FOUNTAIN WIND PROJECT

FINAL ENVIRONMENTAL IMPACT REPORT – VOLUME 1

Use Permit No. UP 16-007
State Clearinghouse No. 2019012029

Comment Letter P26

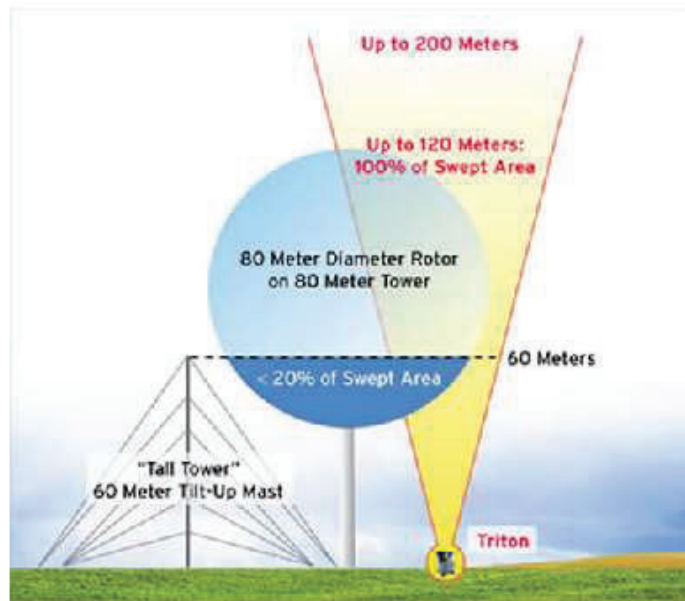
installed MET towers is insufficient to fully address and ascertain the probable power output of this Project. It is suggested that extrapolating Wind Shear characteristics based on sub-hub-height wind measurement data is inaccurate especially in a forested environment. LiDAR or SoDAR measurements and data sufficient to accurately determine the power curve and estimated power output should be included in this DEIR. How else can a clear and accurate picture of the viability of this project be determined?
